1 APPLICATION SUMMARY

Application information	
Address	2 Highlands Street, STAPYLTON QLD 4207 & 2 Fairway Street, STAPYLTON QLD 4207
Lot and plan	Lot 204 SP316171 & Lot 205 SP316171
Site area	2 Highlands Street: 37,660m ² 2 Fairway Street: 42,320m ² (access easement only)
Type of development and proposed use	Combined application for a Material change of use (Warehouse), Reconfiguring a lot for an access easement, and Operational works for a change to ground level.
Categories of development and assessment	Code assessment
Properly made date	9 January 2025
Decision due date	11 September 2025
Applicant and Applicant's consultancy team	FPI Queensland Pty Ltd – Applicant Gassman Development Perspectives – Planning Consultant Acoustic Works – Acoustic Consultant Rytenskild - Traffic Consultant
Owner details	Australand Industrial No. 89 Pty Ltd
City Plan version	Not applicable
Zone / Precinct	Low impact industry, Future low impact industry precinct, Medium impact industry, Future medium impact industry, High impact industry.

The purpose of this report is to assess an application for a Development for a Material change of use to establish a Warehouse, Reconfiguring a lot for an access eas

Figure 8: Possible additional car parking area (Source: Applicant submitted material)

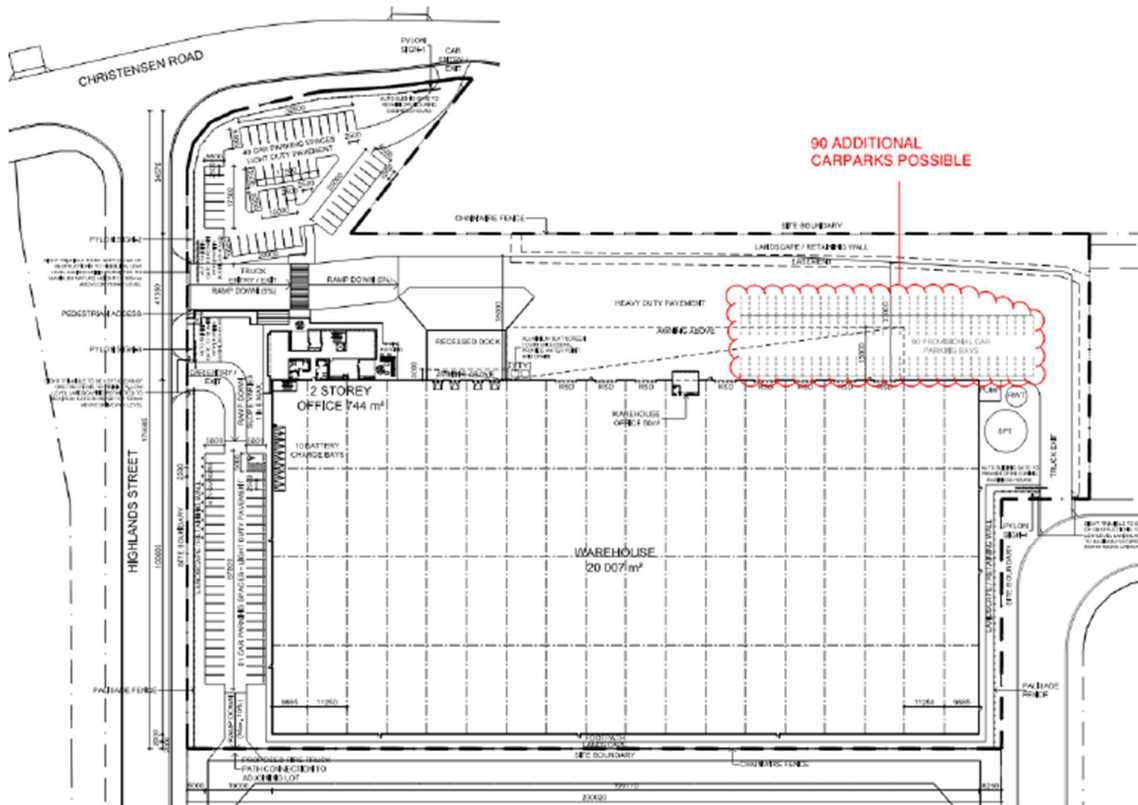
- As the proposed industrial building is capable of supporting other industrial uses as envisioned within Precinct B of the Vantage Industrial Estate, the applicant has demonstrated that additional car parking can be provided within the site should a future user have a higher car parking demand (below image). An additional 90 car parking spaces are able to be supported

adjacent the excess loading bays. It is anticipated that if a manufacturing use was to occupy the tenancy requiring more staff, lesser logistical activities would be required allowing for the reduction in accessible loading bays.

The development proposal is considered to demonstrate that the car parking supply will sufficiently cater for an intended logistical user, with the ability to provide additional staffing should manufacturing activities require a higher car parking provision.

On this basis, compliance with Performance criteria PC8 has been demonstrated.

Figure 9: Excerpt of site plan illustrating the pedestrian route from the car parking location to the ancillary office area (Source: Applicant submitted material amended by City officer)

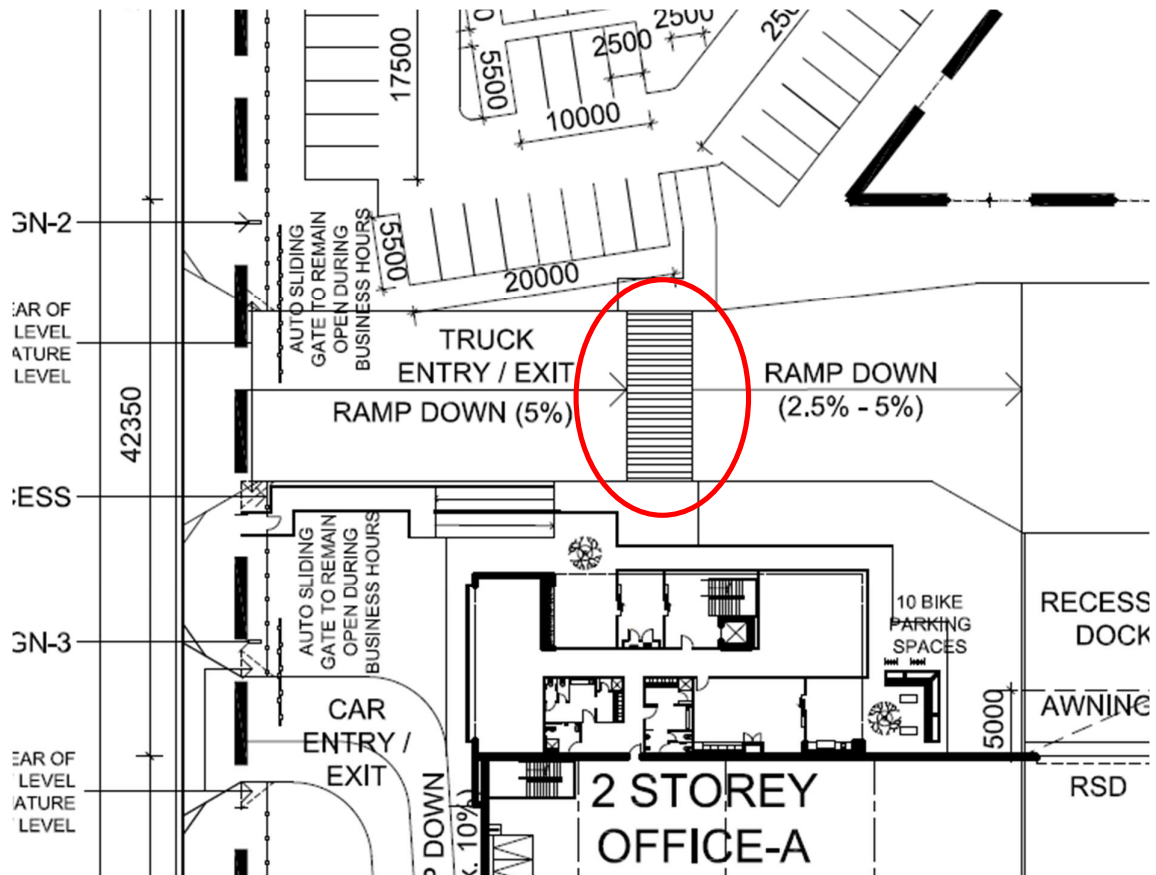
The staff vehicle parking areas are located separate to the heavy vehicle access points. The layout design situates 50 car parking spaces adjacent the ancillary office, minimising potential for conflicts between vehicles and pedestrians within the site. The western most car park facilitates 46 carparking spaces, separated from the ancillary office by the truck entry/exit location. To manage conflicts between heavy vehicles and pedestrian activity within the site, a pedestrian crossing is located across the driveway ramp approximately 28m within the site (below image).

The location of the pedestrian crossing internal to the site provides suitable visibility for heavy vehicles entering the site with sufficient space for the largest service vehicle to stand within the site when yielding to internal pedestrian movements. Further, landscaping is provided around the

extent of the car parking areas guiding pedestrians to the designated crossing locations reducing risk of conflict.

Based on the above assessment, the proposed access arrangement is considered to comply with Performance criteria PC43 and PC55 of the M38 Industrial Estate Place Code, and Performance criteria PC10 and PC18 of the Car Parking, Access and Transport Integration Constraint Code.
